FINAL COMPARATIVE SAFETY ASSESSMENT

**Kansas City Wheeler Downtown Airport
Kansas City, Missouri**

Airport Master Plan

Appendix F Comparative Safety Assessment

Element 1: Hot Spot #1 and Taxiway M

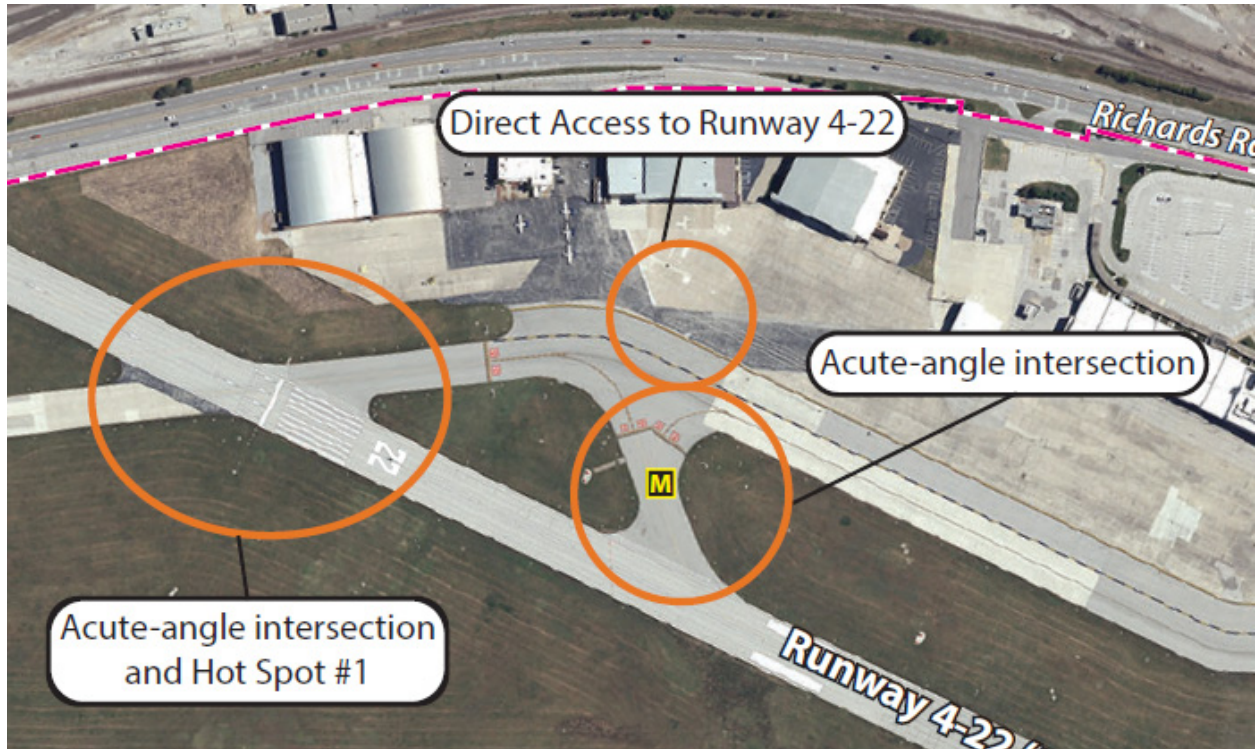
The Taxiway G and Runway 4-22 intersection is unusual due to the angle of intersection. Wide expanses of pavement at taxiway entrances and taxi paths that provide direct access to a runway can lead to loss of situational awareness for pilots and vehicle operators, which increases the risk of a runway incursion. Taxiway M provides direct access to the Runway from an Apron.

- The increased number of aircraft turns required in each of the proposed alternatives is a concern for pilots and controllers alike.
- The increased number of runway crossings by pilots increases the possibility of a runway incursion.
- Potential negative impact by snow removal activities as plows could be in the RSA intersection for both runways, which would require closing both runways for a longer period of time during the snow removal activity.
- Adding complexity without improved safety.

- Increased taxi time in the instrument landing system (ILS) critical area due to changed geometry and taxiway turns.
- The proposed taxiway geometry would cause conflict in simultaneous operations; since Runway 4 is the ILS runway and aircraft exiting Taxiway G eastbound would result in additional runway crossings.

- The number of incursions is shrinking at Hotspot #1; and given the change in occurrence the no change option may be an acceptable solution. Per FAA during the last few years no runway incursions events were attributed to the hot spot (See **Sub-Appendix C**). Regardless of runway incursions, the hot spot indicator would likely remain simply to alert pilots to be extra vigilant in this area. The addition of in-pavement runway guard lights and/or elevated runway guard lights is recommended as an added safety measure.

- None of the proposed alternatives was selected.
- No taxiway geometry changes to the current airfield configuration were recommended based on operational concerns (See General Comments).
- Participants agreed to research and add a proposed in-pavement stop bar and/or runway guard lights at the taxiway prior to the intersection of Runway 22 and Taxiway G.
- Participants agreed to include the proposed no-taxi islands as depicted in each alternative.

ALTERNATIVE 2

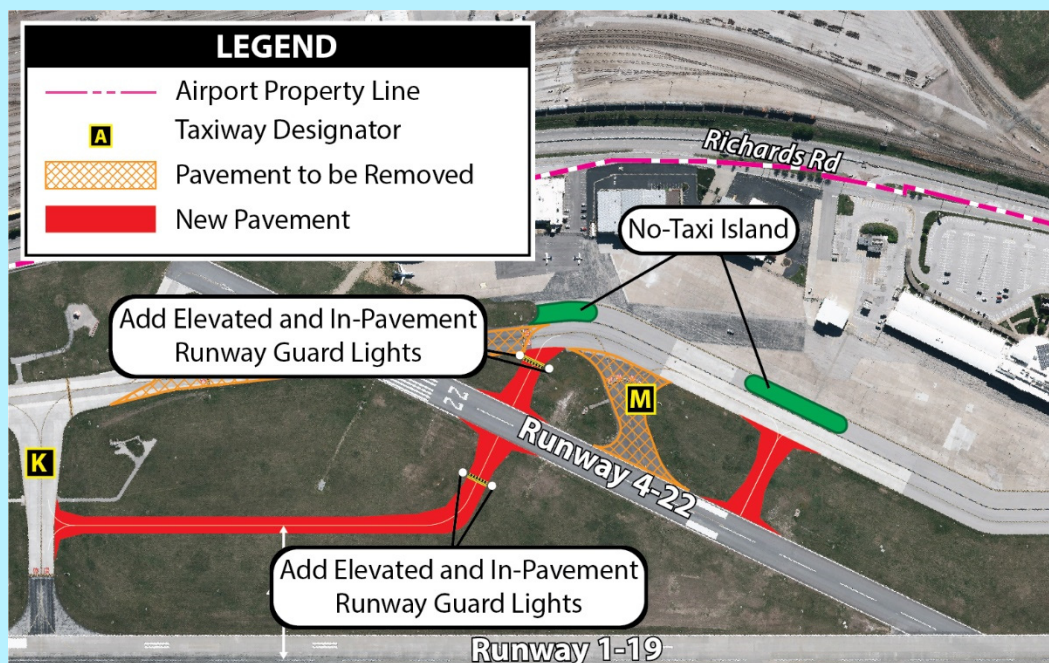
- The No-taxi island solution provides visual cues when operating on Taxiway G and Taxiway M.
- Additional stop bar and/or runway guard lights prior to the intersection of Runway 22 and Taxiway G would improve situational awareness.
- May be difficult for aircraft on Taxiway G to hold perpendicular; however hard turns would improve situational awareness.

- Alternative 2 is not ideal for similar reasons as Alternative 1 including takeoff distance, additional turns, student traffic, and snow removal constraints.
- Pilots could miss the new Taxiway G entirely when exiting Runway 1-19 at Taxiway K due to the new location of Taxiway G.
- The number of turns to taxi from ramp to the runway is increased. Currently the taxi route includes one turn, whereas the new alternative results in as many as five turns.
- For aircraft operating on Runway 1 and exiting right on Taxiway K will create a conflict with aircraft coming off Taxiway K and the new proposed taxiway.
- Runway 22 is used as an exit by student pilots landing on Runway 1 because it takes too long to get to Taxiway K. This creates additional congestion.
- If a pilot is holding short of the new Taxiway G on either side of Runway 4-22, pilots will not be perpendicular to the runway.

ALTERNATIVE 3

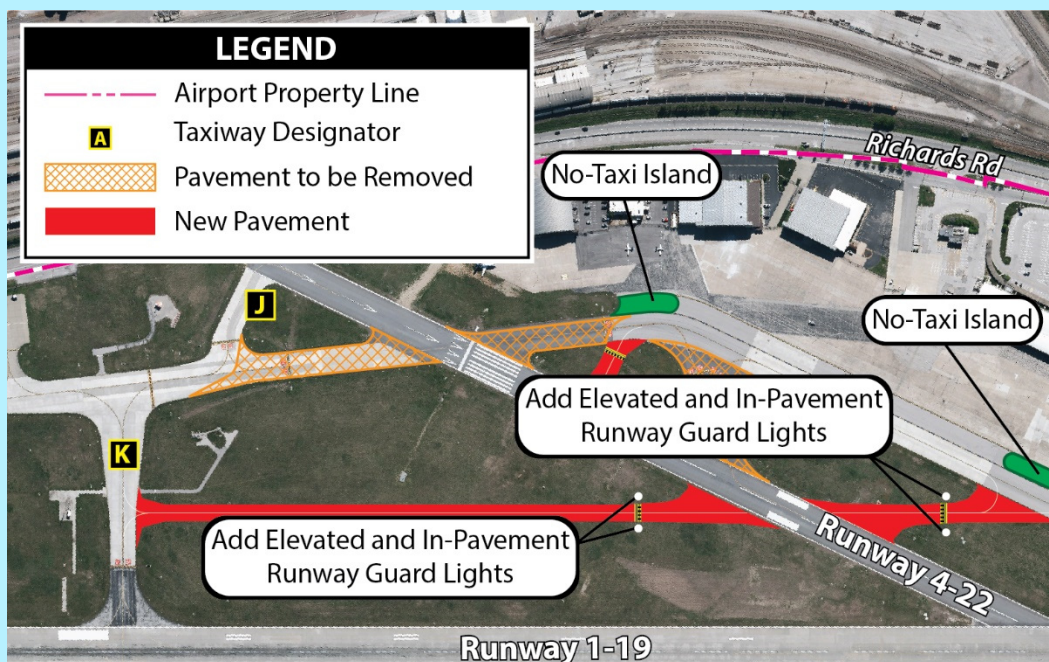
- The No-taxi island solution provides visual cues when operating on Taxiway G and Taxiway M.
- Additional stop bar and/or runway guard lights prior to the intersection of Runway 22 and Taxiway G would improve situational awareness.
- Parallel taxiway is a familiar layout for pilots.

- The proposed parallel taxiway would cross Runway 4-22 in the high-energy area (middle third of the runway). Per FAA, taxiway crossings through the high energy area are not recommended.
- If a pilot is holding short of the new Taxiway G on either side of Runway 4-22, pilots will not be perpendicular to the runway.
- The intersection of Taxiway K and the new Taxiway G may be a choke point as there may not be sufficient spacing or clearance if an aircraft exited Runway 1-19 onto Taxiway K and was stopped after crossing the hold bar. Larger business jets might not be able to maneuver past the holding aircraft when taxiing south using Taxiway K to access the new Taxiway G.

Element 2: Hot Spot #2 - Taxiway D Direct Access to Runway

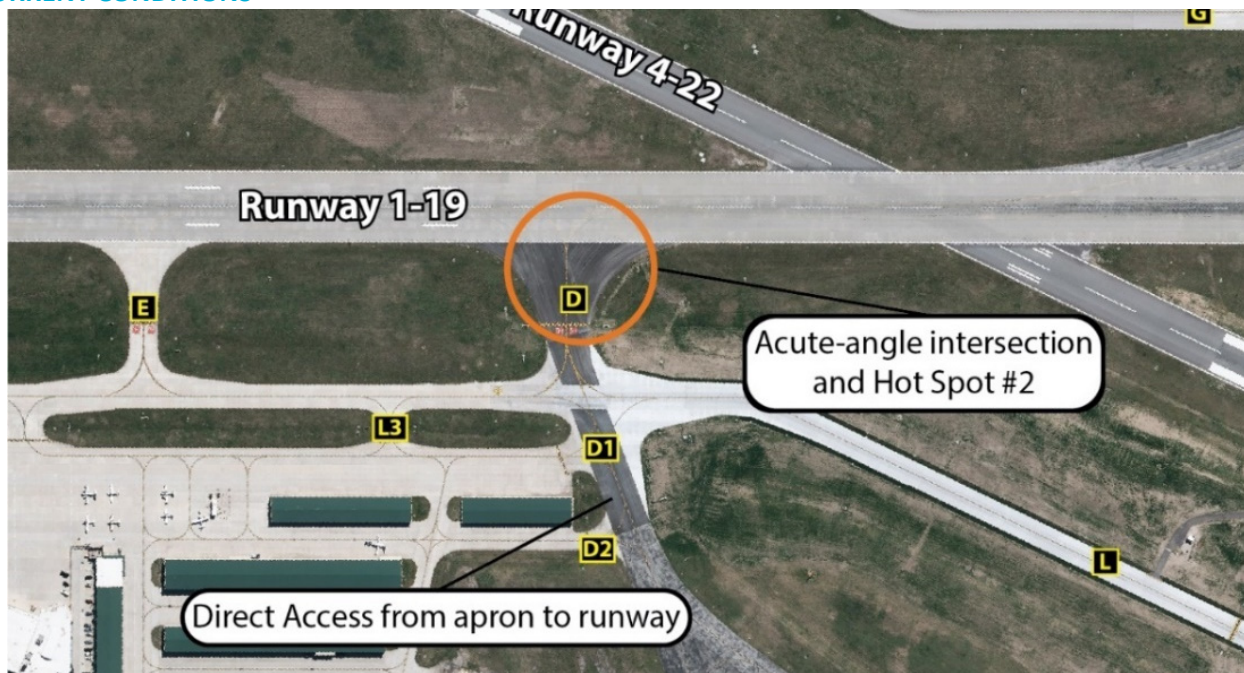
The proposed alternatives are intended to resolve a direct apron to runway access issue (taxilane leads from apron area to runway). When this was discussed previously, shifting that portion of Taxiway D between the runway and Taxiway L was not supported because it was thought that the new connection would be too close to intersection of two runways thus being potentially confusing to pilots. Taxiway D is also a wide expanse of pavement and is planned to be narrowed to a 90-degree to mitigate the existing geometry.

- Wider pavement is desired for aircraft maneuvers at the Taxiway D exit.
- Runway guard lights provide additional pilot situational awareness.

- The current use of Taxiway D is primarily for aircraft exiting Runway 1-19 for both north and south flow landings.
- Narrowing the pavement in this area would restrict aircraft movements and operations.
- Removing the wide fillets limits aircraft in back taxi operations and maneuvers.
- For aircraft attempting to exit at Taxiway D, additional pavement allows larger aircraft to make turns; otherwise, pilots need to taxi to Taxiway B which reduces capacity and requires a runway crossing.
- Medevac aircraft also require the additional pavement which would impact on their operations.
- The Airport needs to balance uniform taxiways and standards with operational benefits including wider taxiways in some areas; this could be considered in the future.
- A larger taxiway separation from runway intersections is beneficial for pilot situational awareness.

Alternative 2 was selected as the preferred option.

ALTERNATIVE 2

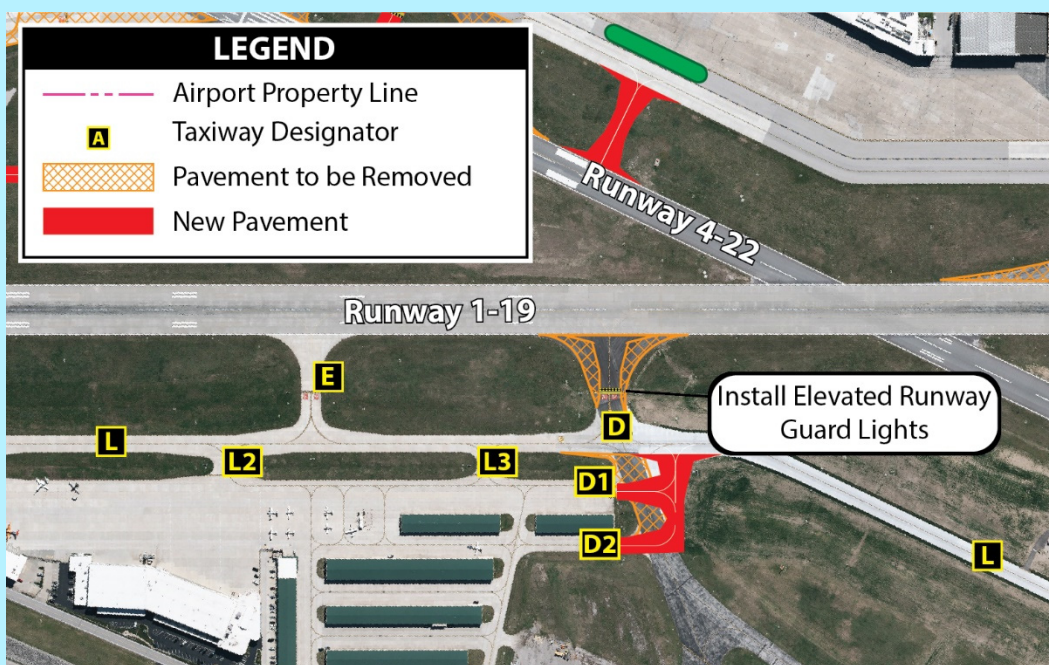
- Provides standard 90-degree taxiway angle.
- Removes direct access issue.
- If the primary reconstruction of Taxiway D occurs on the west side of Taxiway L, then the amount of time for runway closure will be reduced.
- Improves the line of sight for the tower for aircraft departing the T-hangar area.
- Some adjustment to the pavement (angled, not 90, wide flare) will be planned; however, a case could be made that Taxiway D could be wider. (See General Comments)
- Install elevated runway guard lights to enhance situational awareness.

- Feedback from the CSA committee indicated a concern for narrowing Taxiway D between Runway 1-19 and Taxiway L as large business jets use this exit and aircraft may benefit from a wider than standard width.
- Shifting the west portion of Taxiway D would slightly reduce the area available for hangar development.

ALTERNATIVE 3

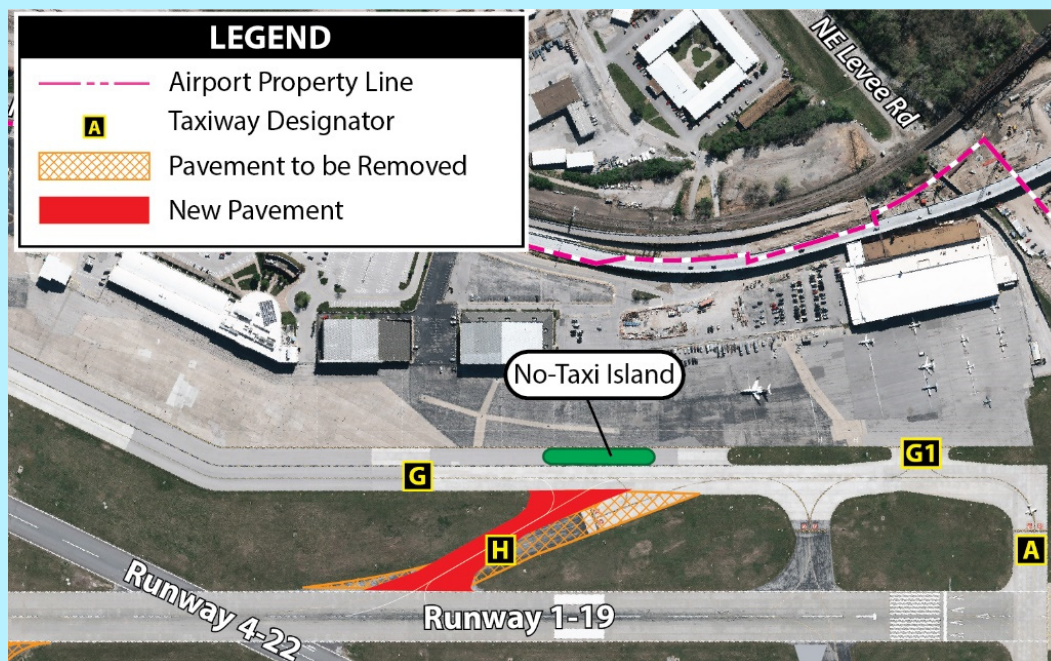
- Enhances runway capacity by reducing runway occupancy times.
- Continues to provide high-speed exit for south flow operations.
- No-taxi islands are included to prevent direct access from an apron area to a runway.

When it is time for Taxiway H to be reconstructed due to normal use, Taxiway H would be reconstructed at the standard 30-degree angle.

Element 4: Southwest Landside Alternatives **Unconstrained** by Existing Lease Lines

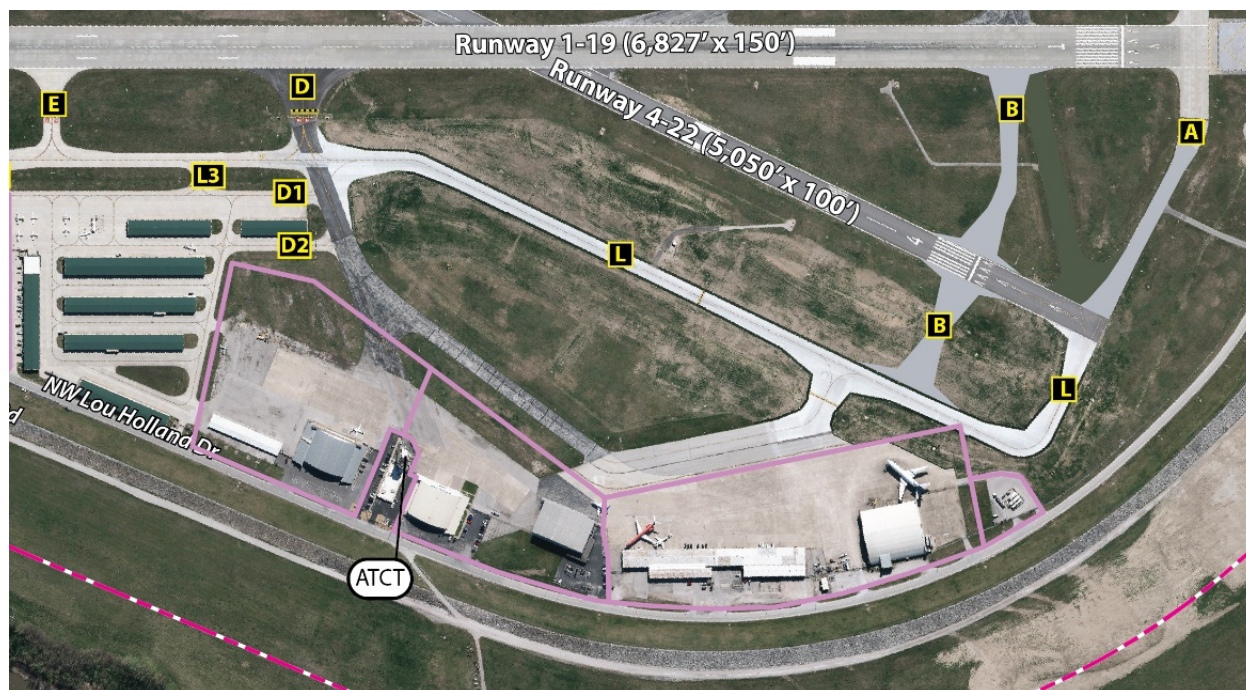
Areas shaded in red are locations that would not be visible from the cab to the ground. The viewshed analysis for each southwest landside alternative is shown in the second figure of each alternative. Additionally, the existing Taxiway F will no longer serve as a taxiway under FAA ATCT control and will be separated by a roadway that enters the area from Lou Holland Drive.

- Segregating the development area with a roadway is required to provide access to the new facilities and to ensure Part 139 compliance for restricting access of pedestrian and ground vehicles (See part 139 329 Pedestrians and ground vehicles).
- Preserving existing lease lines will allow for existing facilities to maintain operations in a single area.
- In Alternative #4, Taxiway L is visible but small portions of the taxiway object free area (TOFA) would be blocked. The height of the proposed hangars could be lowered to make the entire TOFA visible; however, Alternative #5 does not require modifications and thus is a better alternative.

ALTERNATIVE 2

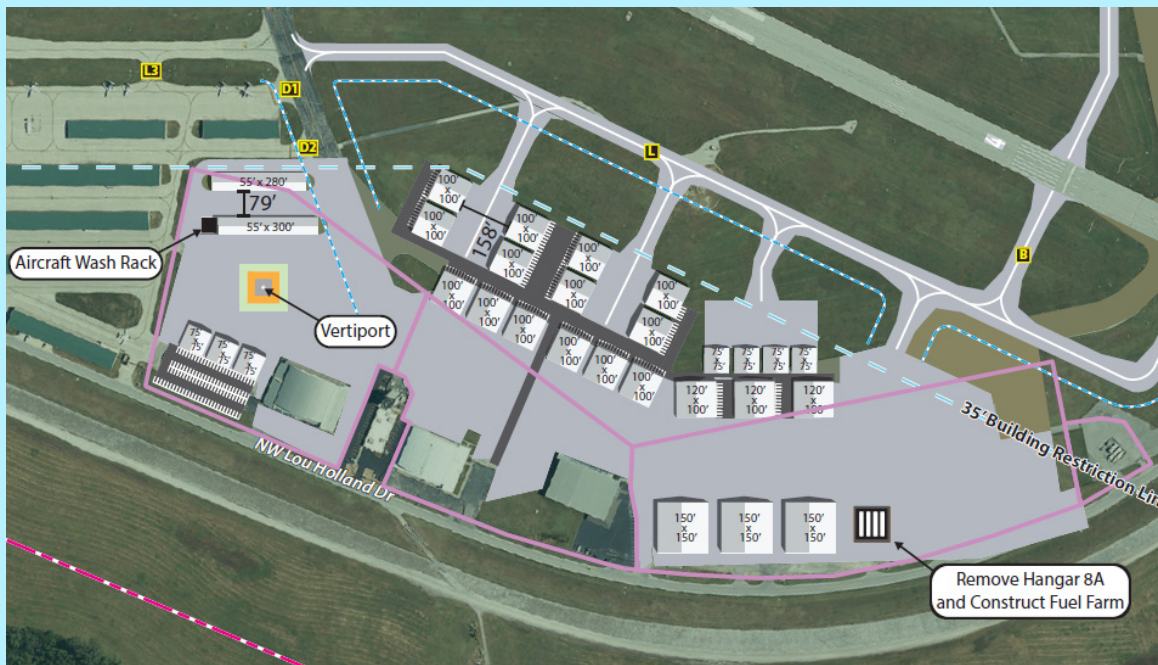
- Alternative #2 was not considered
